**CITY OF NORTH SALT LAKE
PLANNING COMMISSION MEETING
NOTICE & AGENDA
March 24, 2026
6:30 PM**

SUBJECT: Consideration of Preliminary Plan approval for The Yard Subdivision at 1155 North Redwood Road

SUBJECT: Consideration of Preliminary Plan approval for Clifton Place South PUD Phases 1, 2, and 3 at 1095 North Redwood Road

Preliminary Plan The Yard Elevations

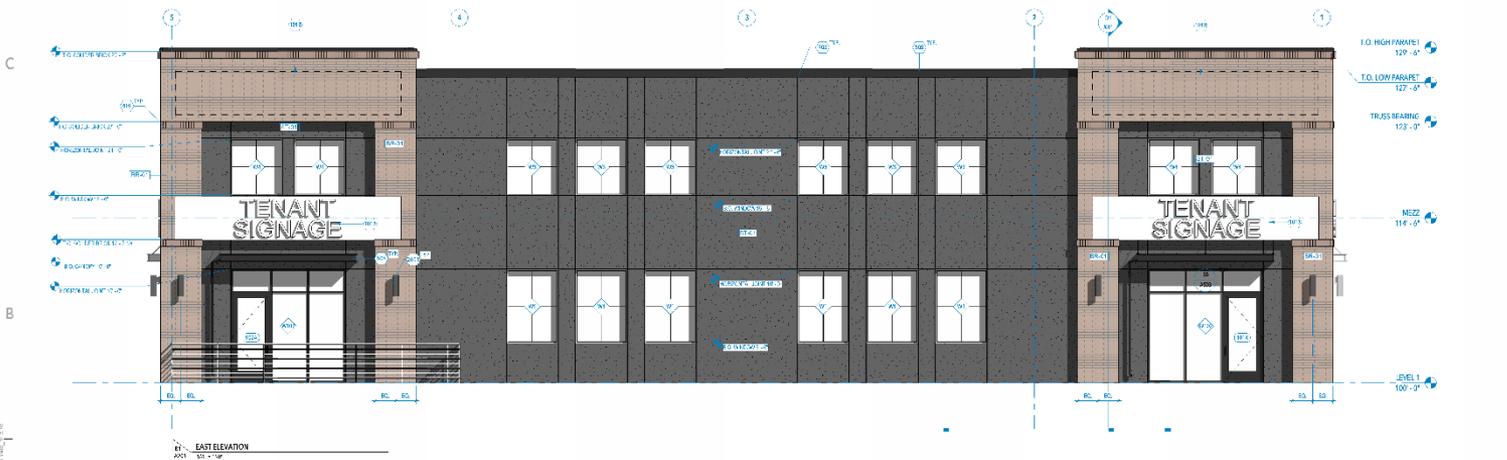
1. The Planning Commission recommends to the City Council that the Development Agreement be amended to increase the maximum front yard setback from 1100 North to 90 feet;
2. Confirmation of South Davis Metro Fire Agency's project acceptance prior to final plat recordation; and
3. Correction of minor redlines related to landscaping, building elevations, utilities, and drainage.

The Development Agreement regulates that commercial buildings be a maximum of 40 feet tall, each façade greater than 50 feet incorporate a wall plane interruption, each roofline includes a variation a minimum of every 50 feet in length, and that the design be consistent with the residential townhomes. The proposed buildings are 29.6 feet tall measured from finished grade to the highest parapet. There are minor redlines on the elevations related to clarification on the color of brick being used and the addition of a brick column and parapet on the east and west sides of the buildings.
